**Re: DA-2356-00 West Centertech – Site Plan  
Comment Response Letter #2**

SITE PLAN  
WEST CENTERTECH

WEST CENTERTECH	
SITE ADDRESS:	16001 E. LOCKHEED DRIVE AURORA, CO 80011
PREPARED FOR:	WEST CENTERTECH, LLC PO BOX 472918 AURORA, CO 80047

SIGNAGE AND STRIPING DETAILS

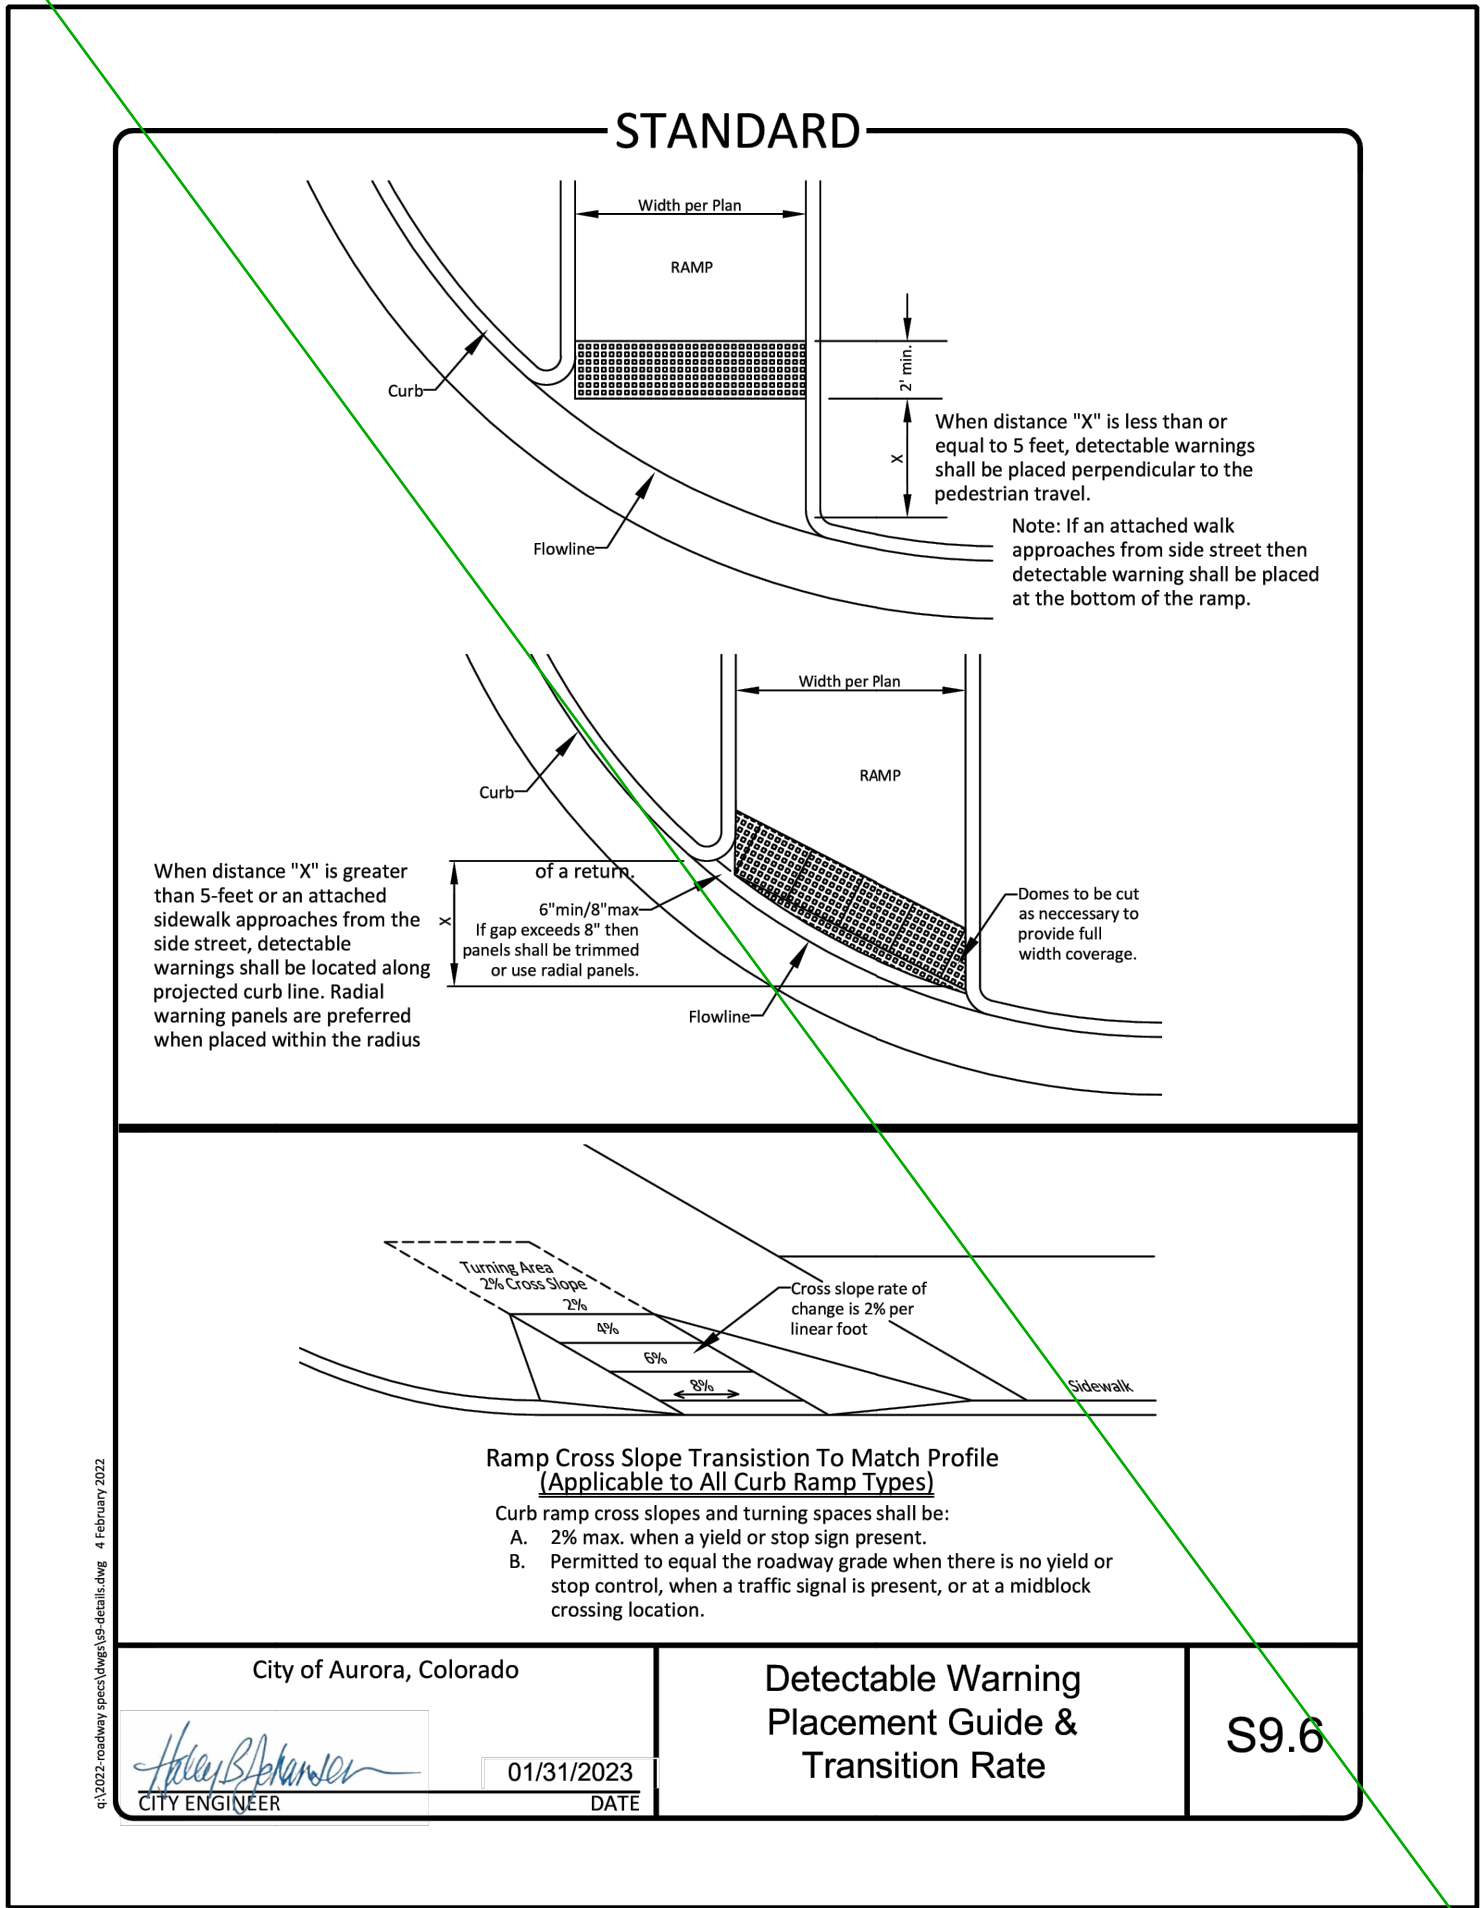
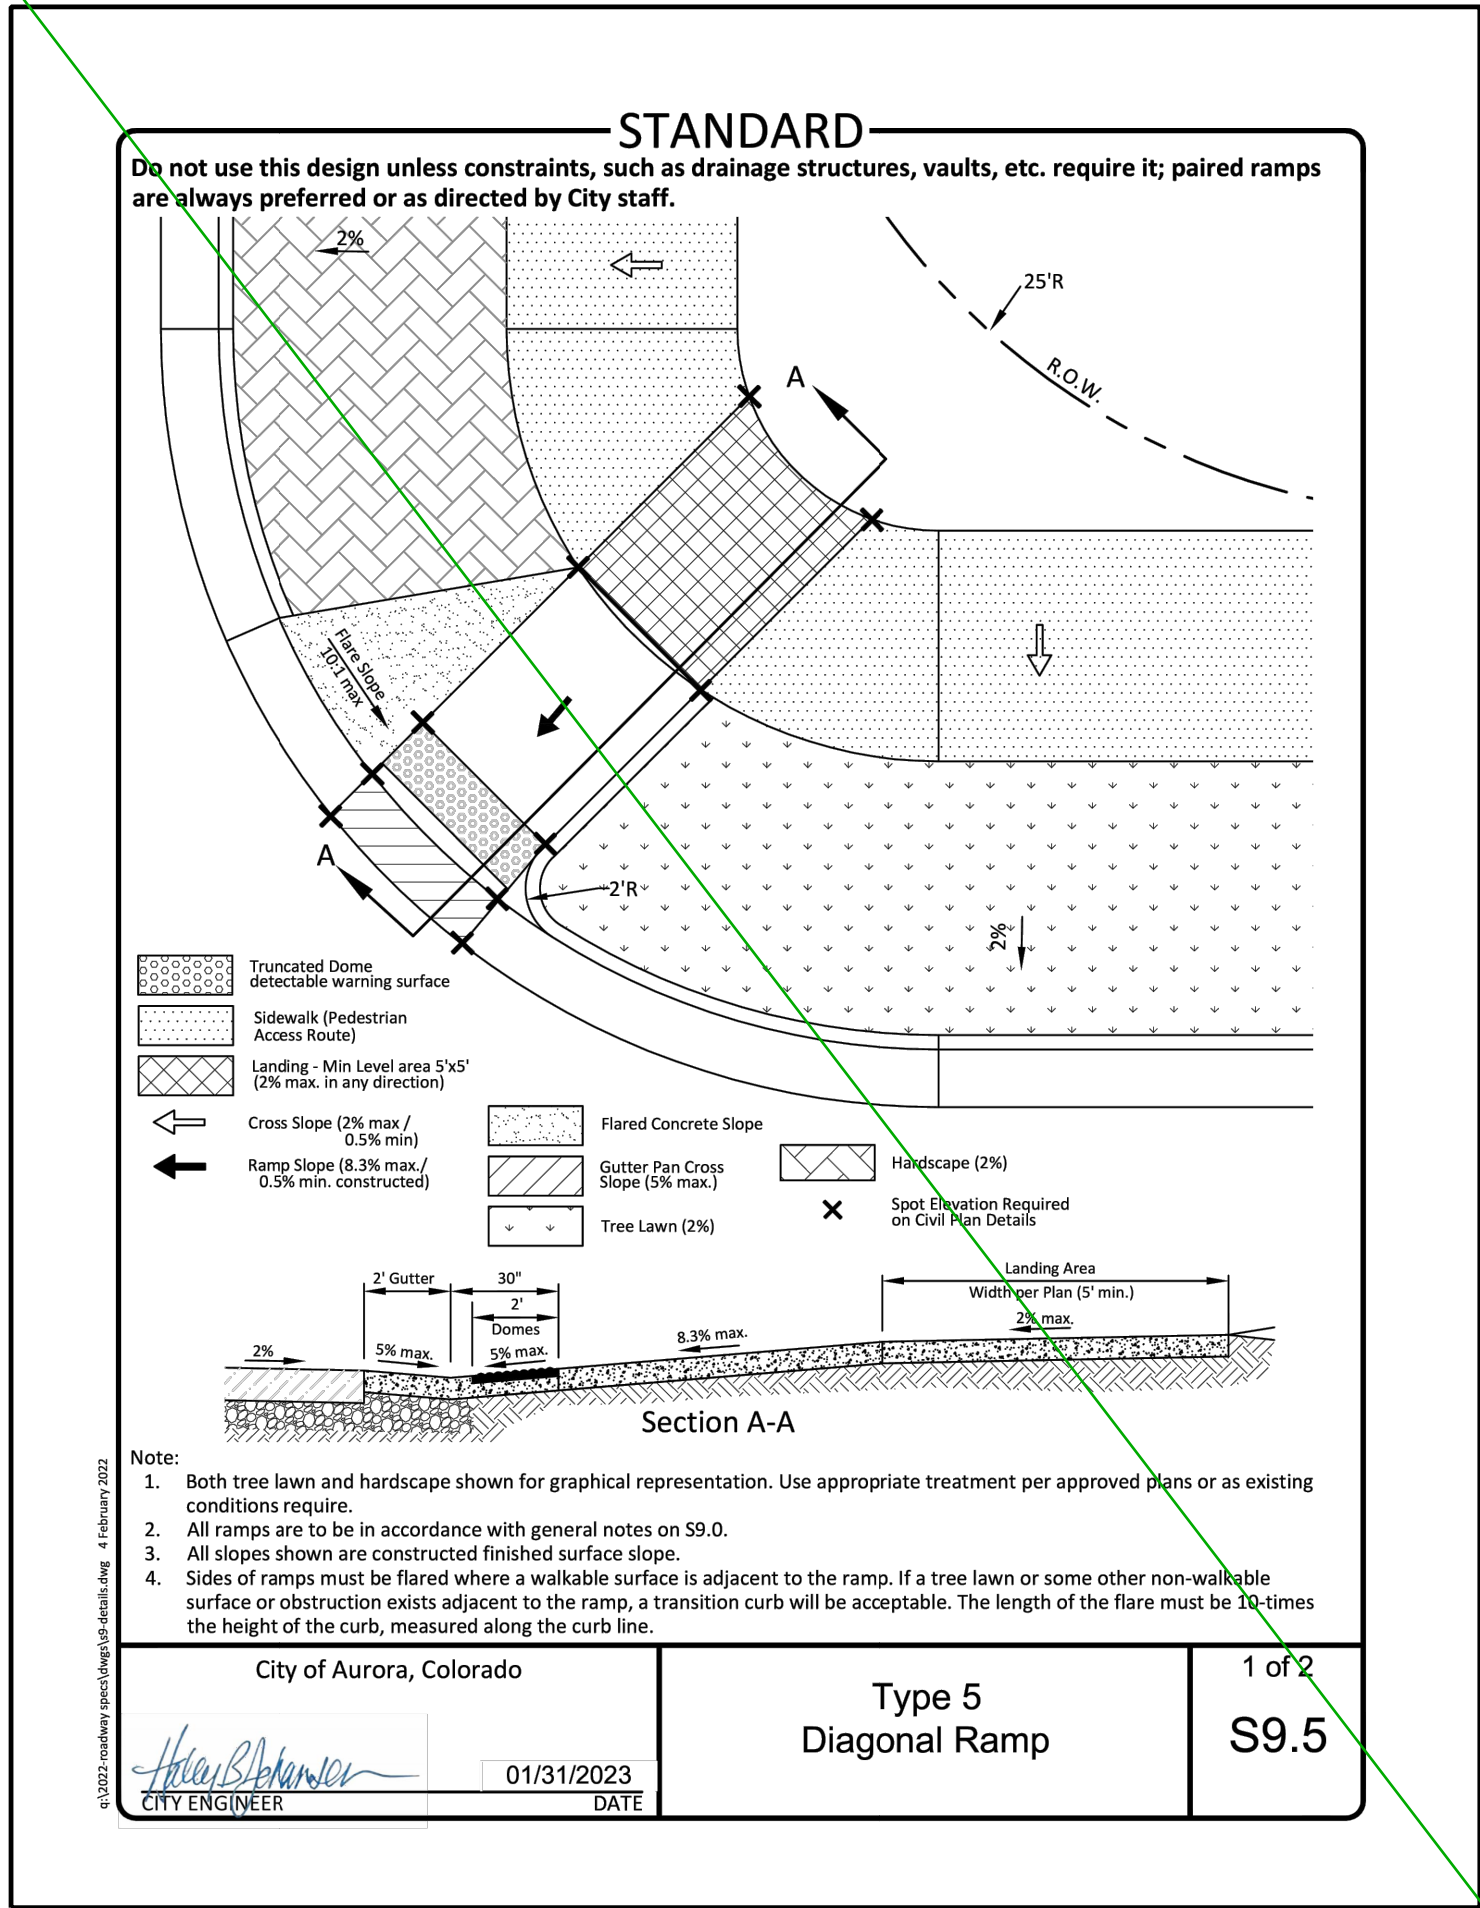
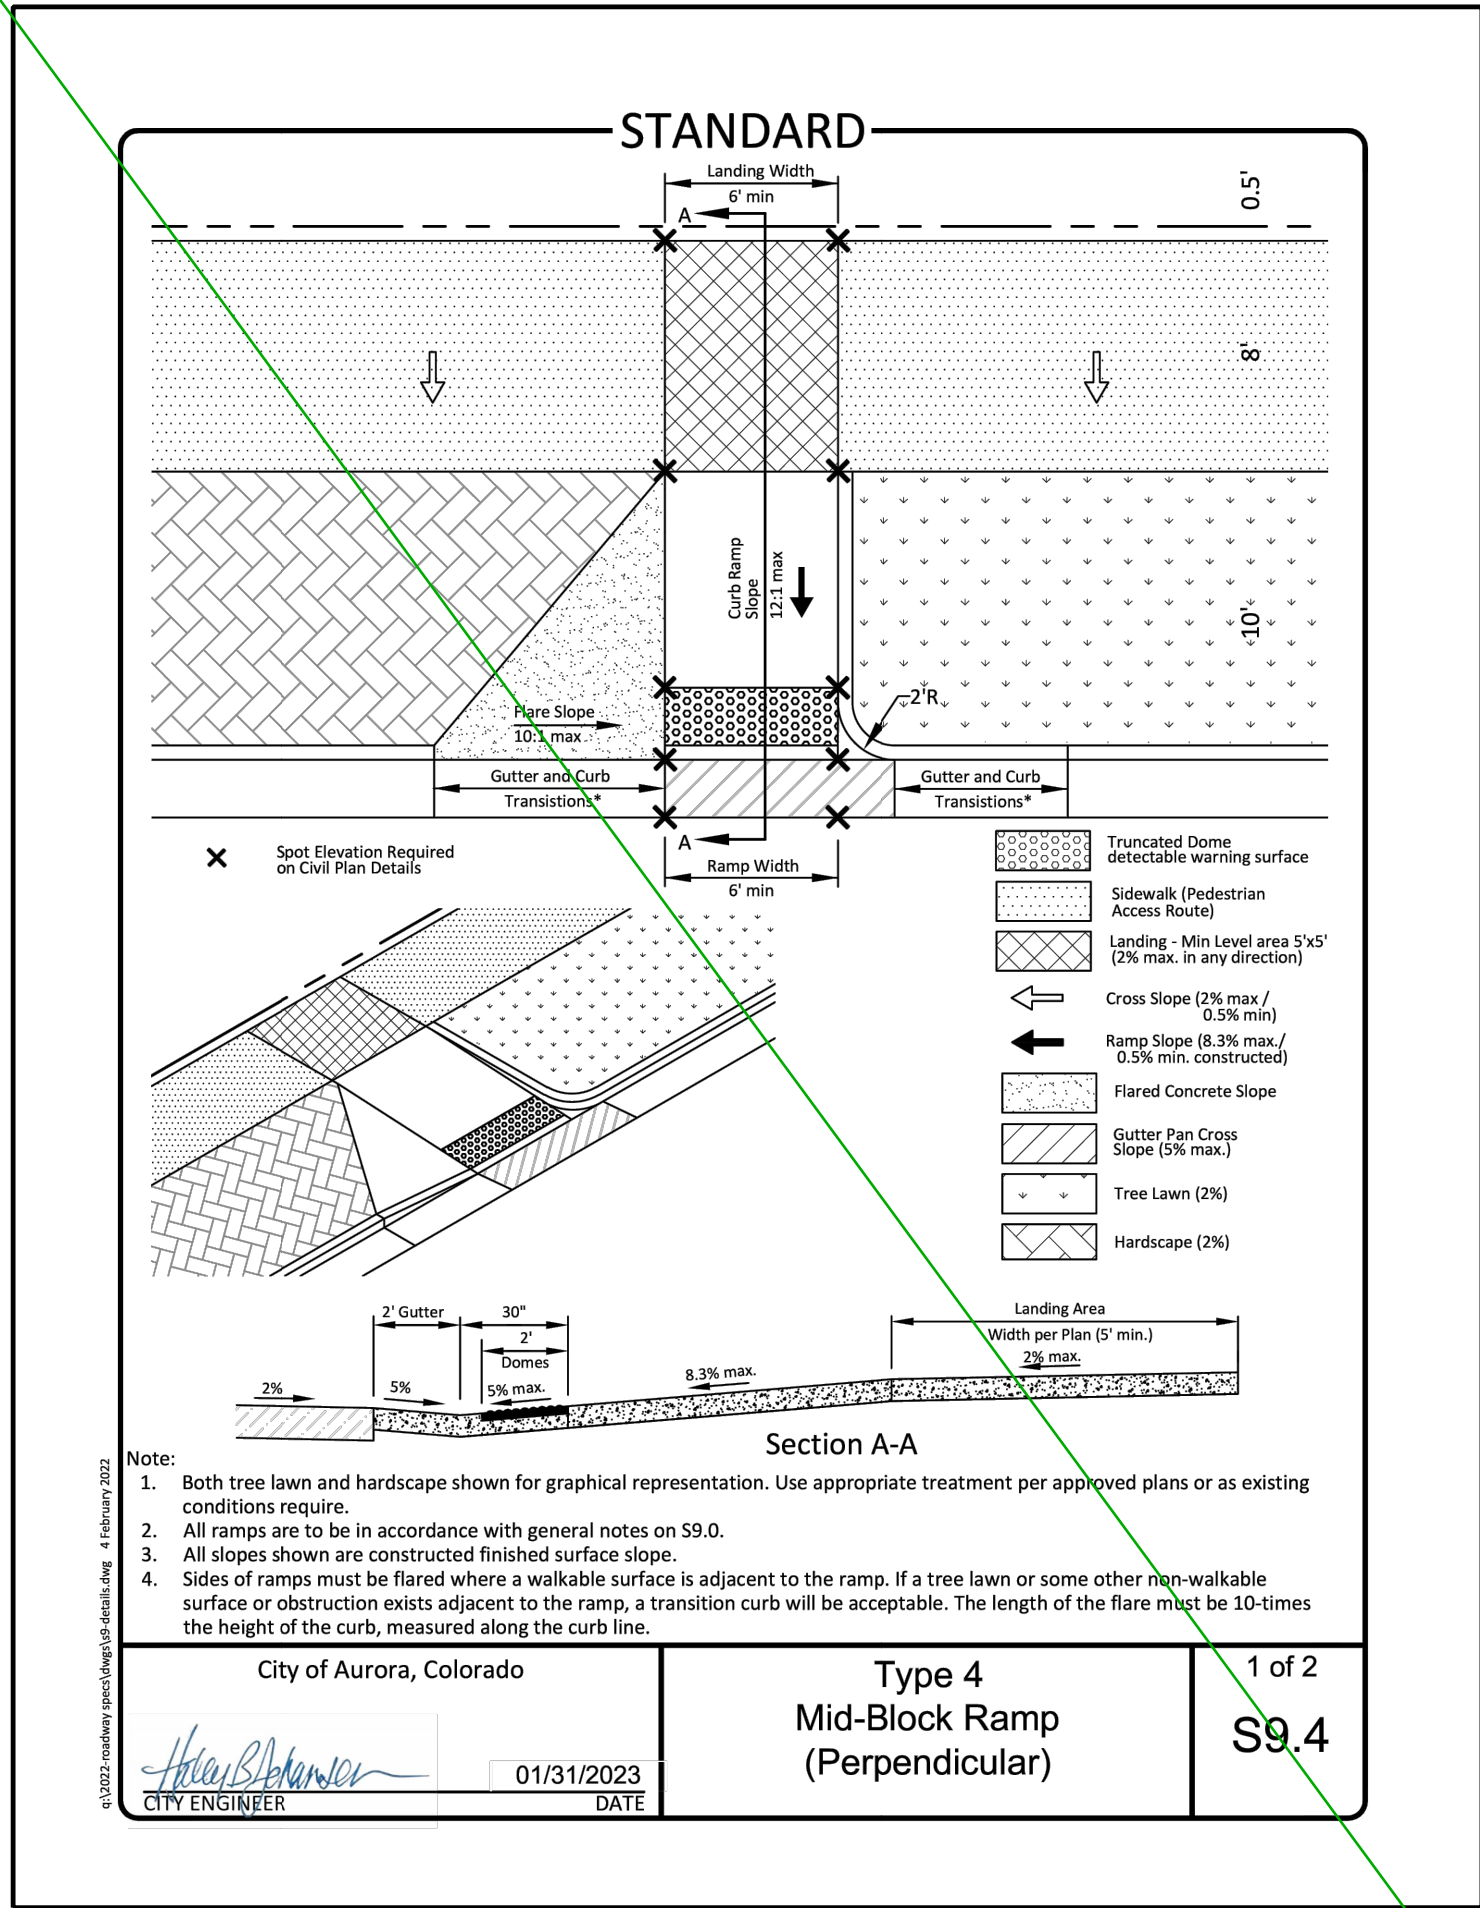
Plans shall include adequate details of special structures not covered by City of Aurora Standard Details. Do not include City Standard Details in the plans, but reference them by detail number, only. (2.03.8 of the 2023 COA Roadway Manual)

Response: Detail sheet has been revised and appropriate labels and details have been added through the plan set.

4 WALL & FENCE ELEVATION DETAIL  
SCALE: NOT TO SCALE

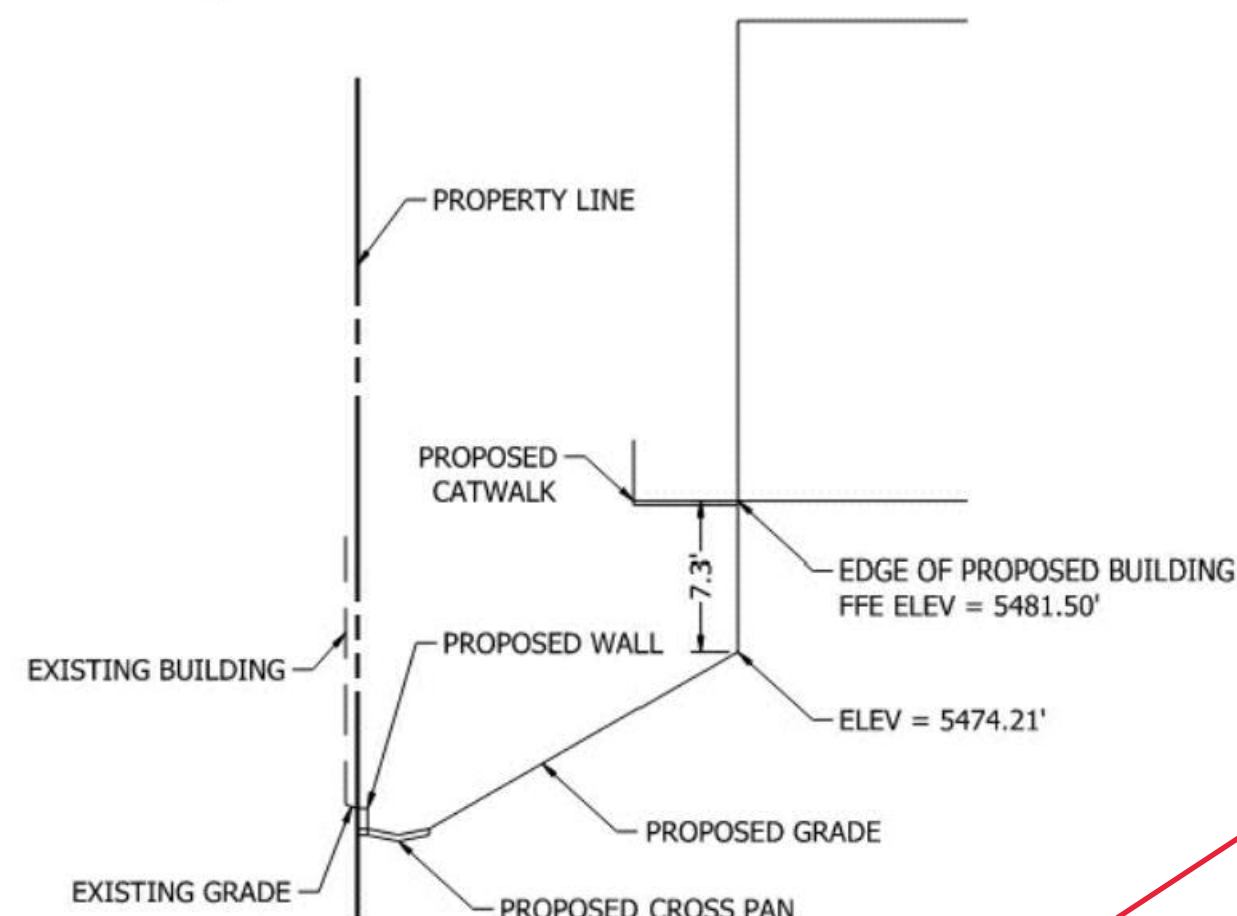
Ensure this is a 3-coat stucco system. EIFS does not qualify as a masonry material.

Galloway Response: The area in front of the wall is a utility easement and is approximately 10' wide. The wall height varies along the frontage but the max height is 5.82'

Galloway Response: The proposed landscaping is not shown for clarity. There will be large shrubs along the wall that will screen most of the wall and some of the fence

Galloway Response: Revised
